ADDENDUM NO. 2

**Coventry Township
NEW FIELD HOUSE
Logan Field
2701 North turkeyfoot Road
Akron, Ohio 44319**

**Prepared by
Four Points Architectural Services, Inc.**

April 29, 2024

1 FOUNDATION PLAN
S1.1 1/4" = 1'-0"

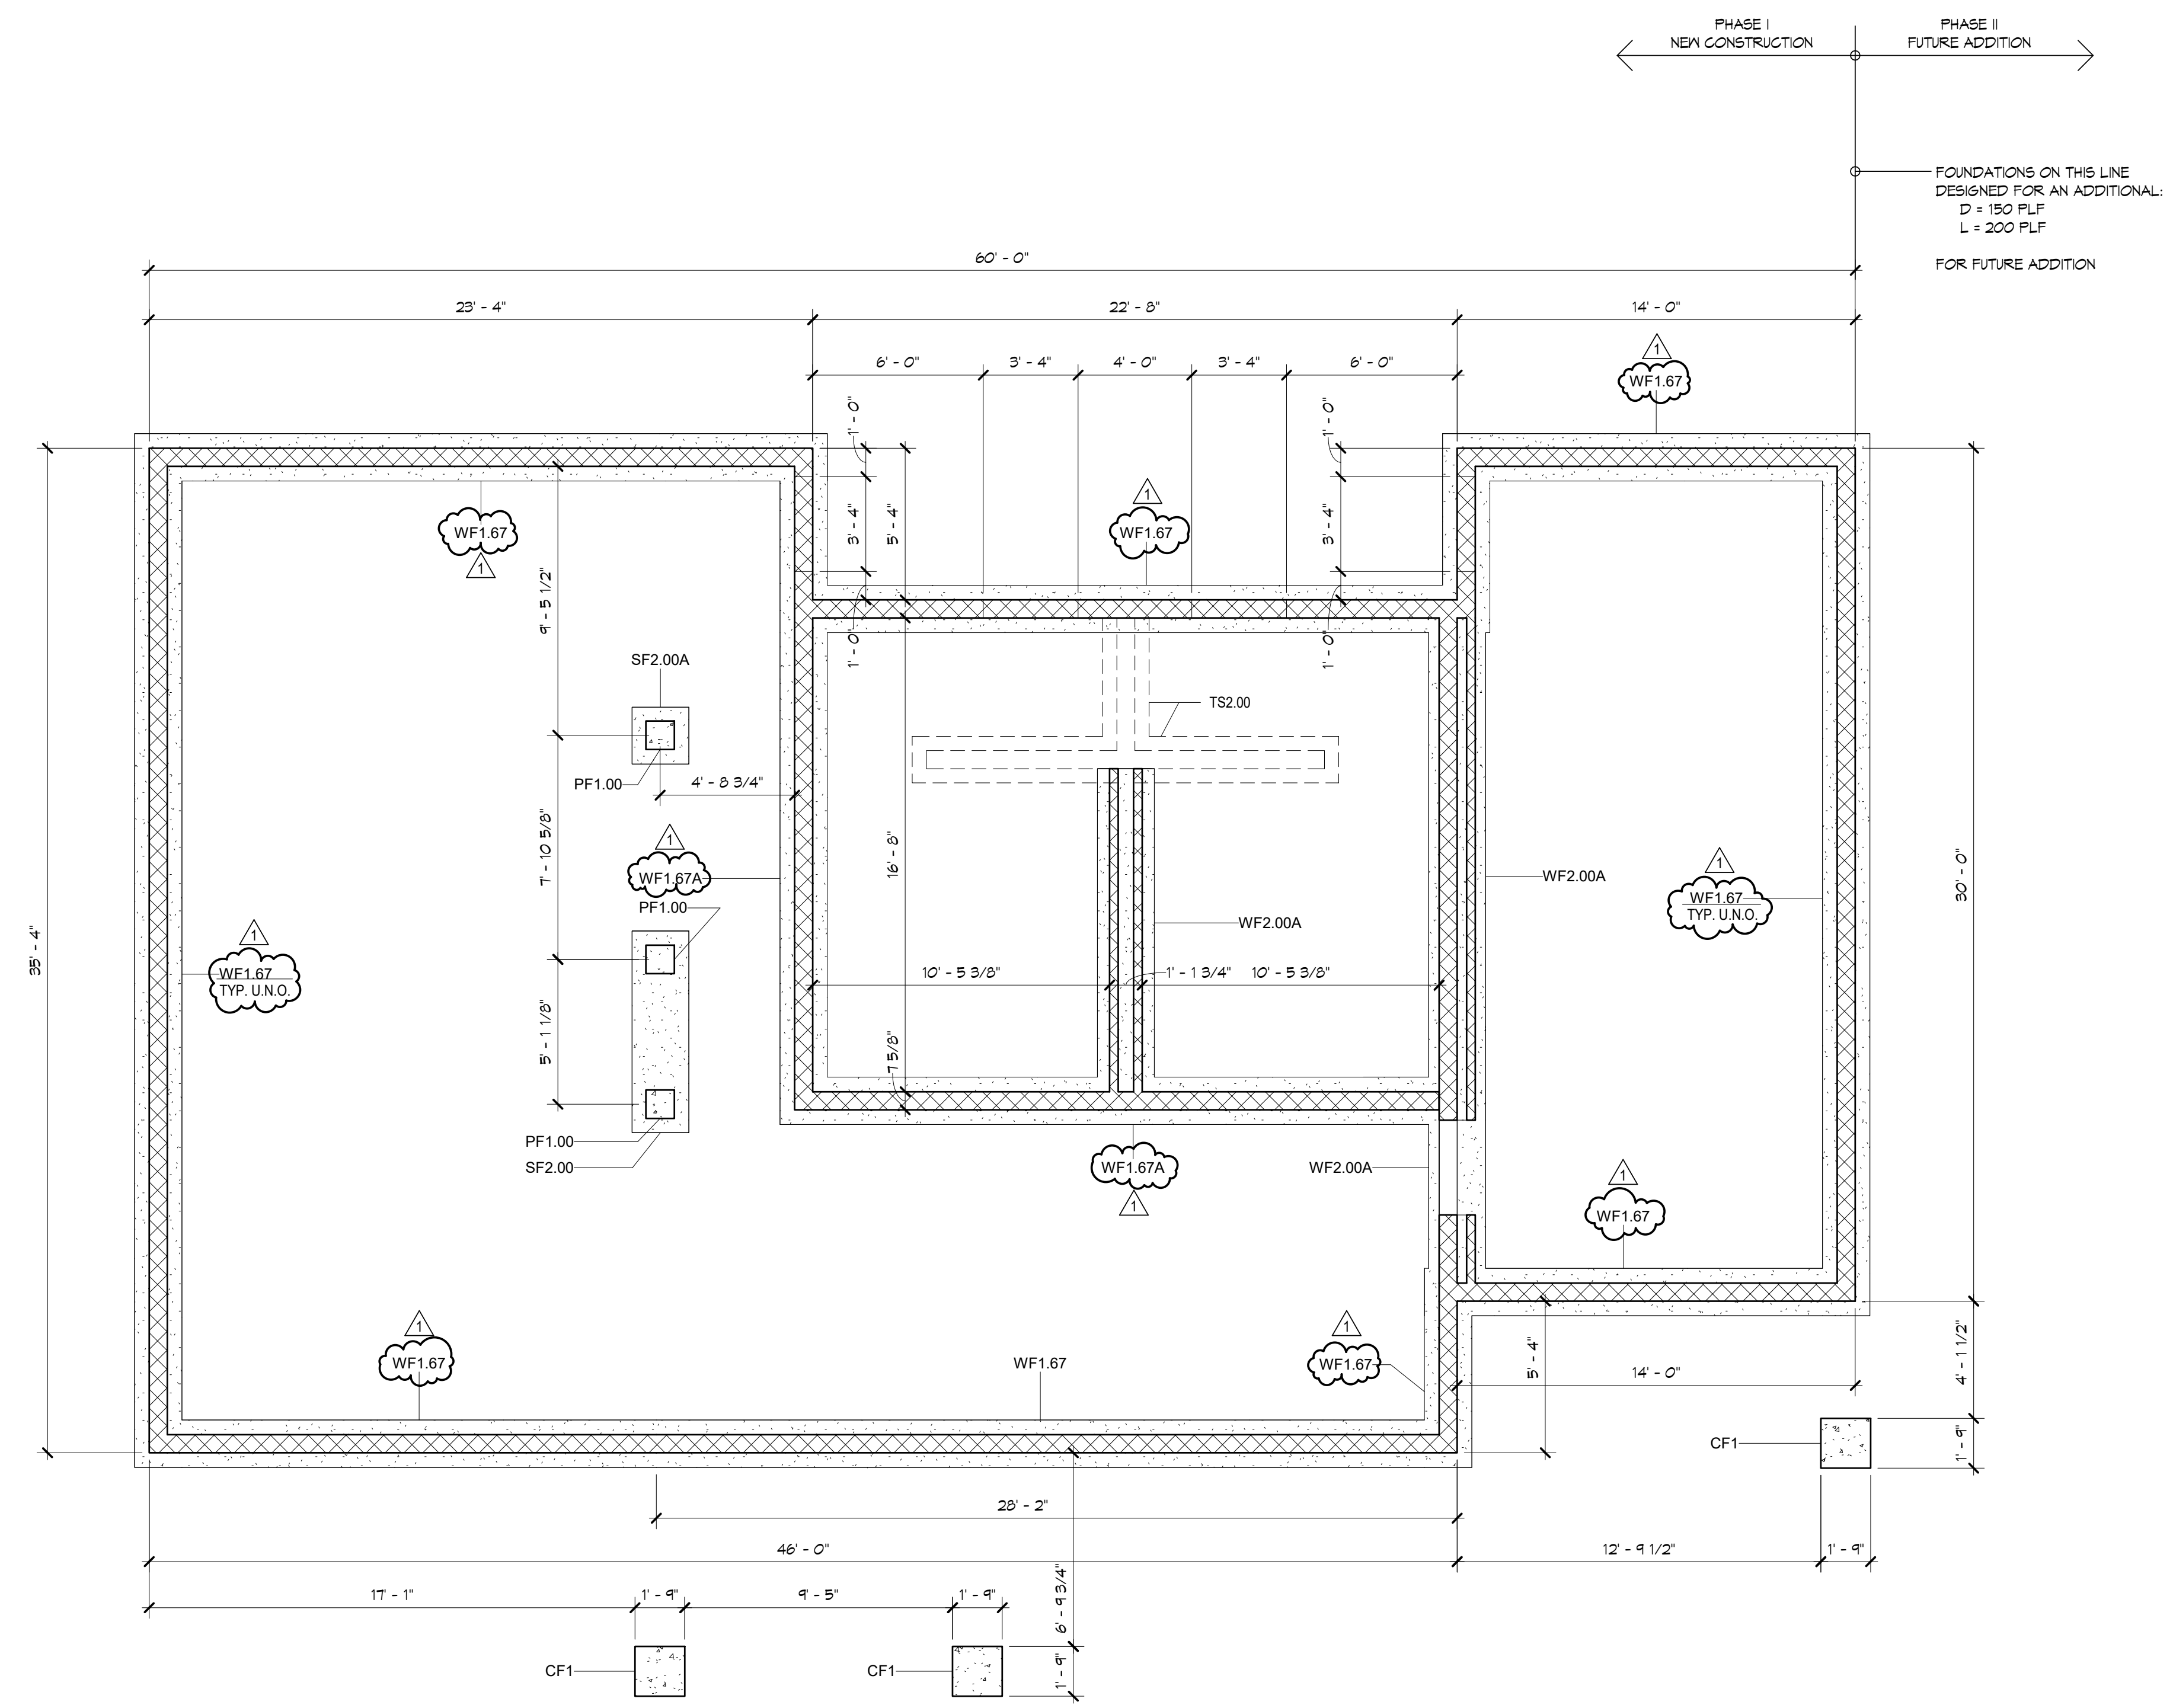
9. **Sheet S1.1 – Foundation Plan:**

- a. To accommodate the soils report recommendations and to simplify the foundation layout, all WF1.33 footings have been changed to WF1.67 footings.
- b. To accommodate the soils report recommendations and to simplify the foundation layout, all WF1.33A footings have been changed to WF1.67A footings.
- c. WF1.67A has been added to the Structural Foundation Schedule.

P2.1
21-025

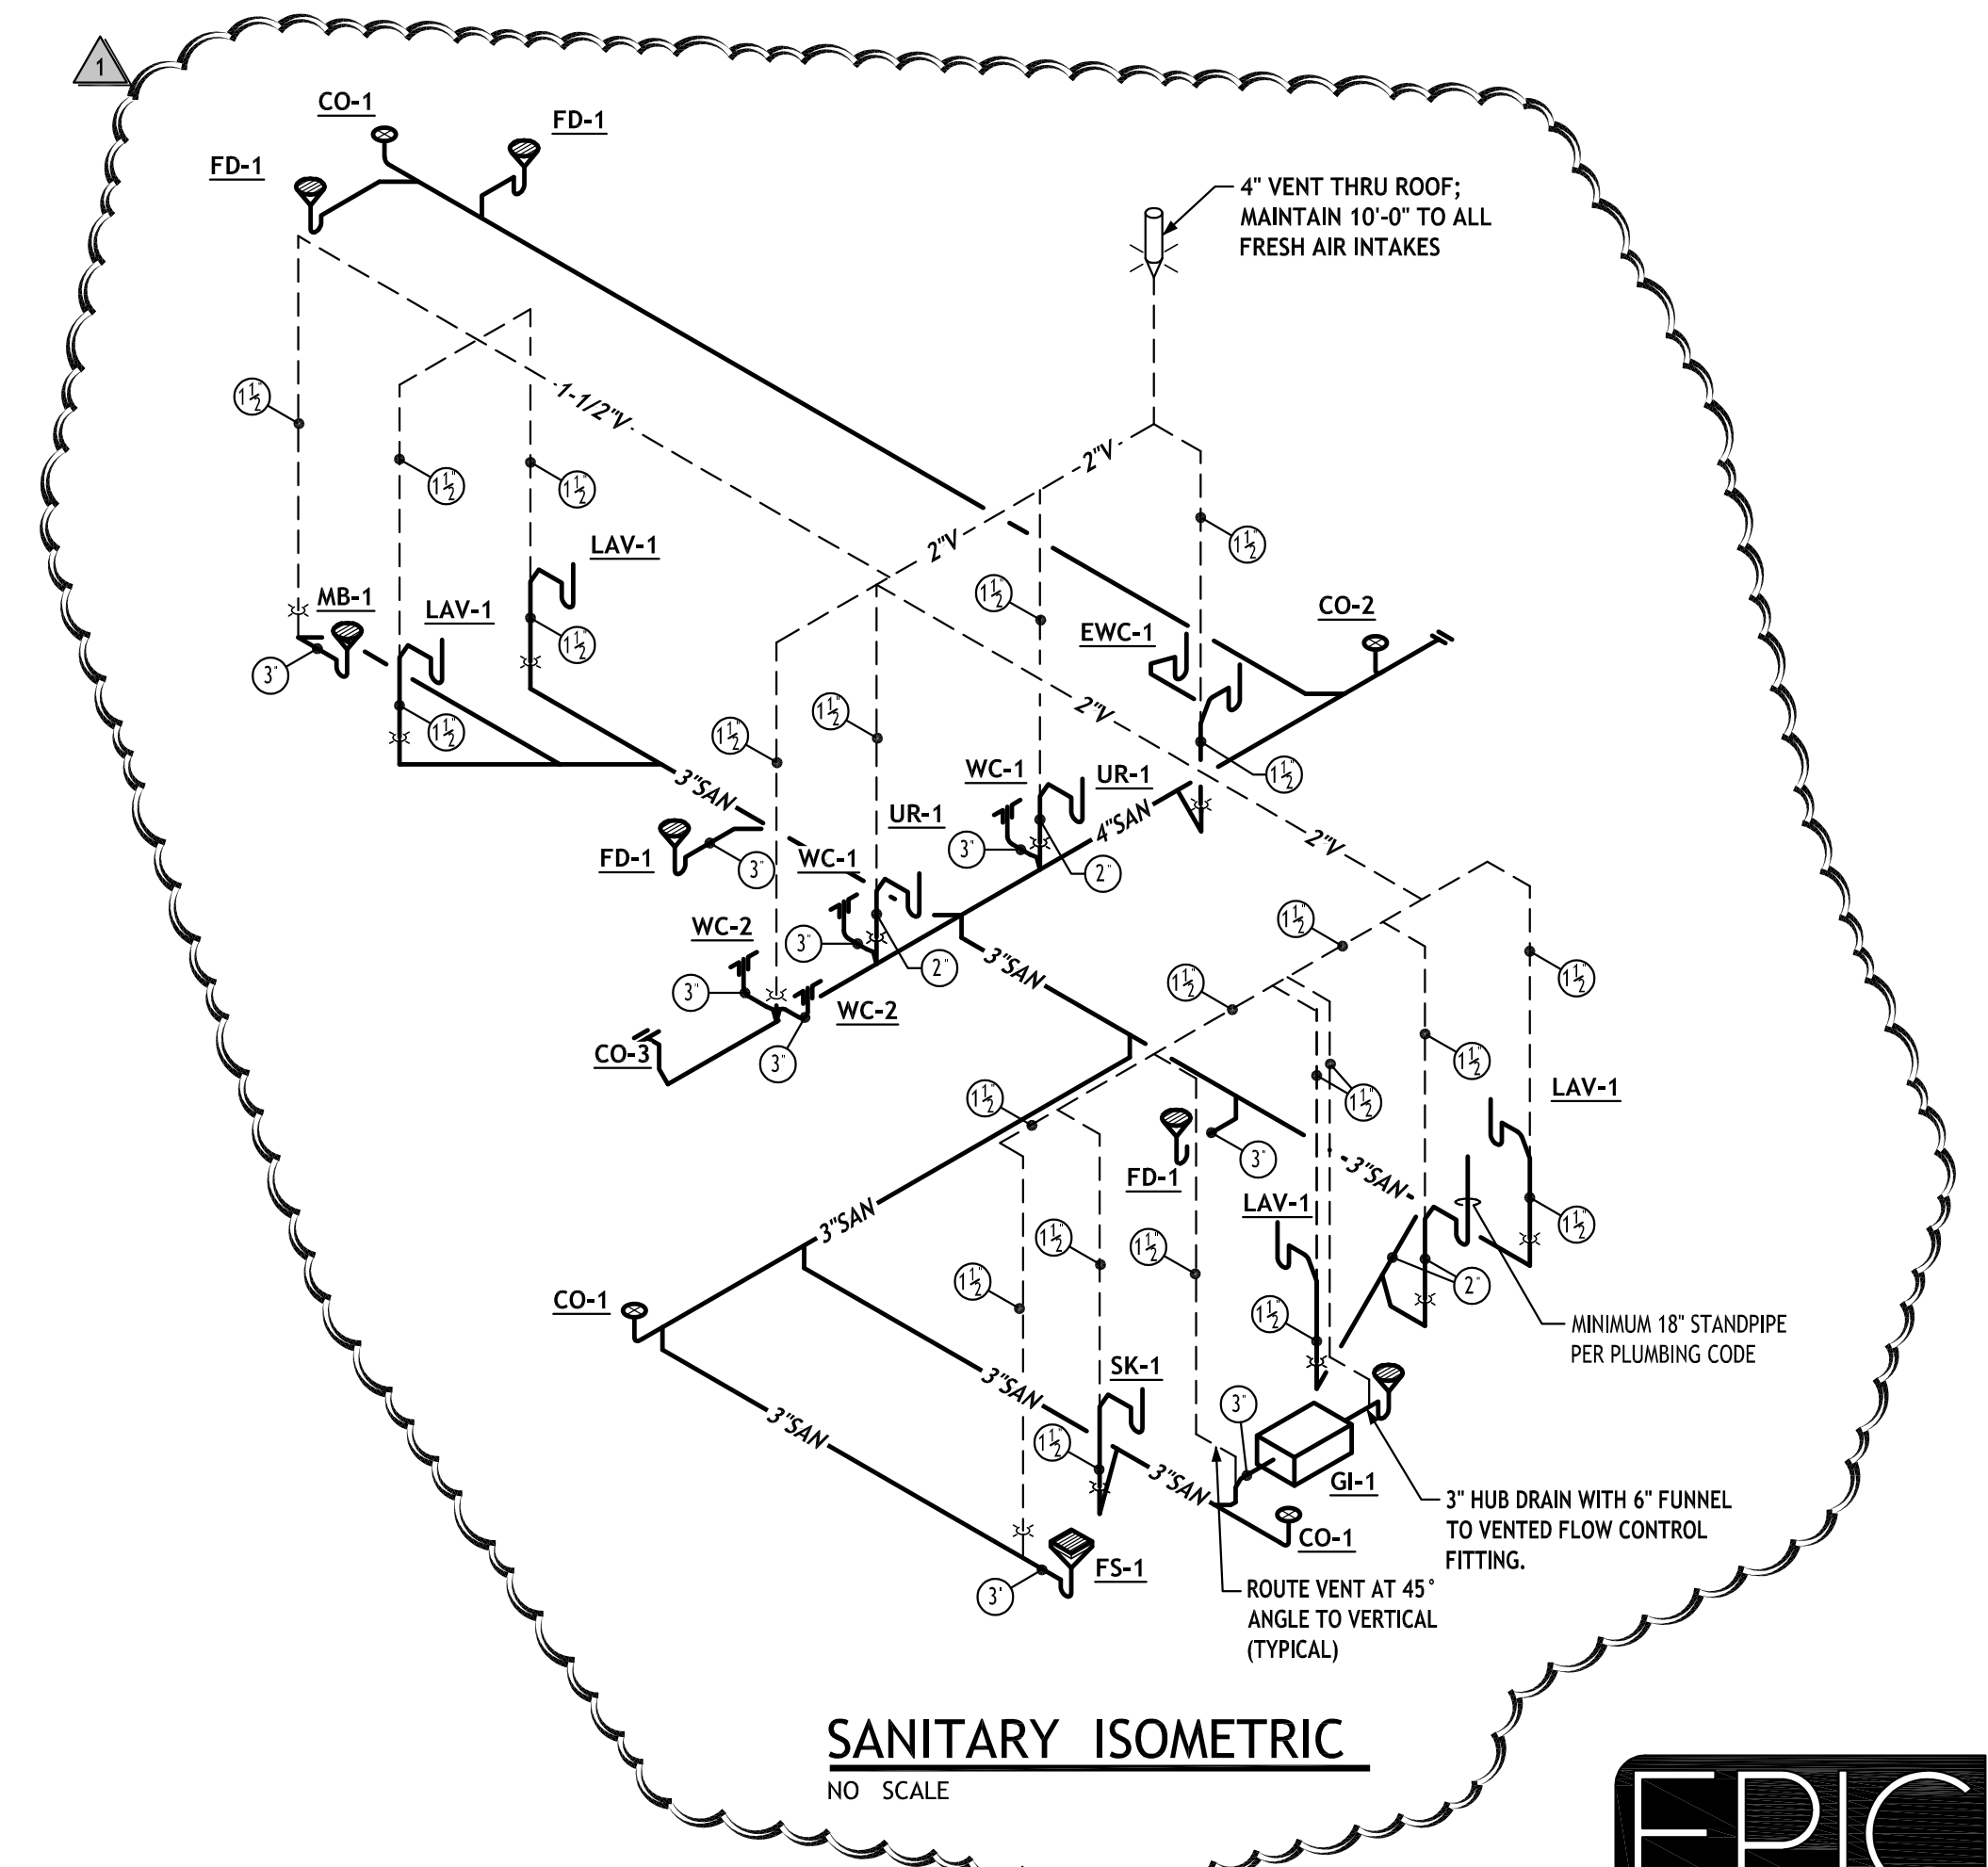
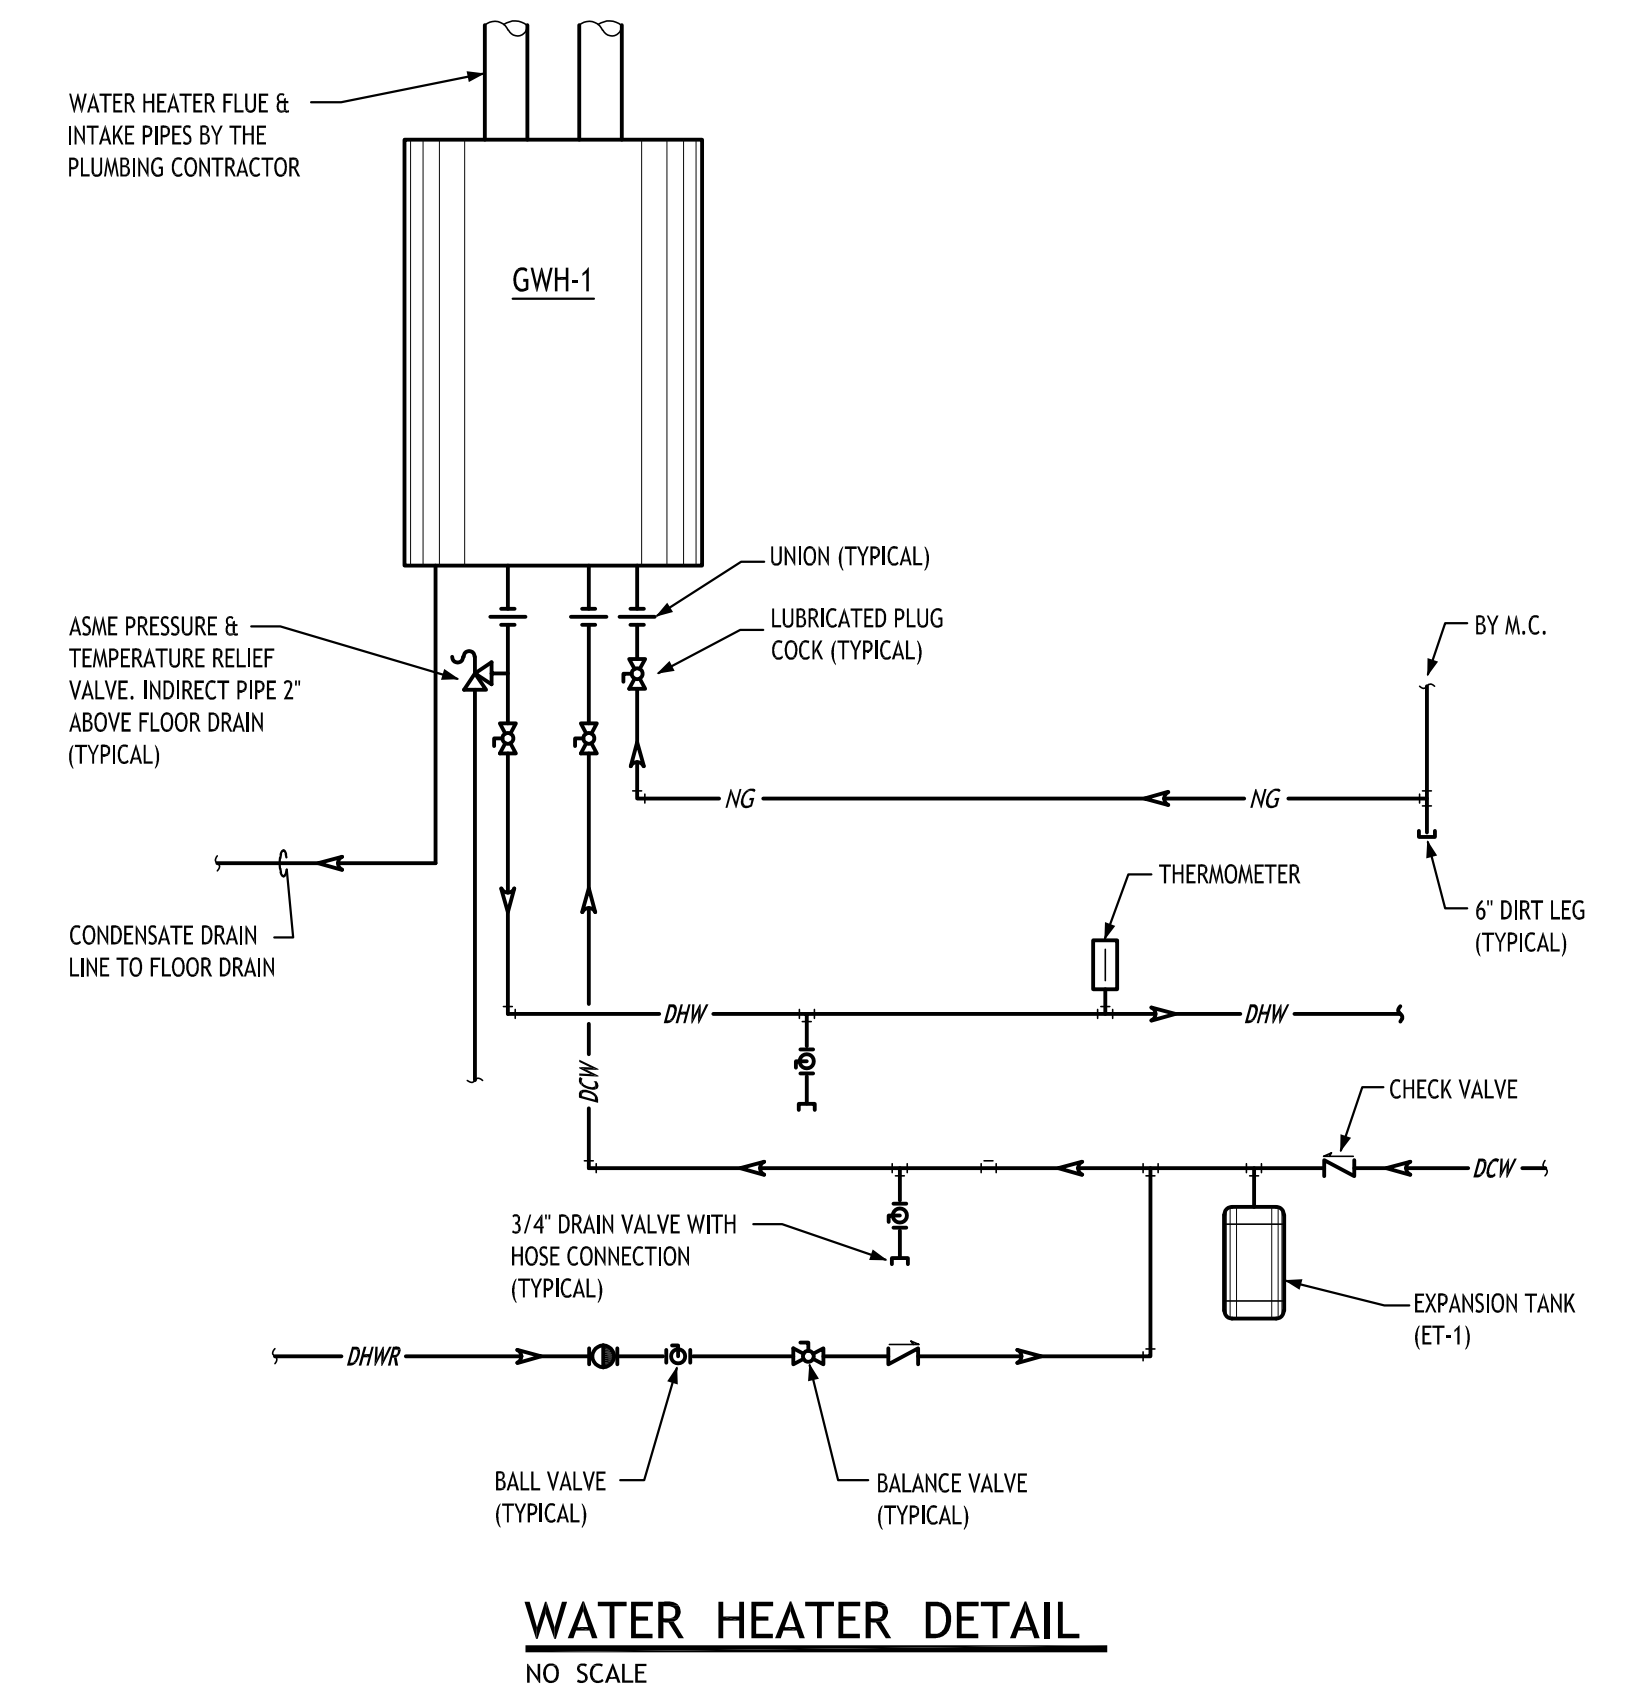
12. **Sheet P2.1 – Plumbing Details:**

- a. The Sanitary Isometric has been updated to include changes to the concession area.
- b. A Grease Interceptor Sizing chart has been added to this sheet.
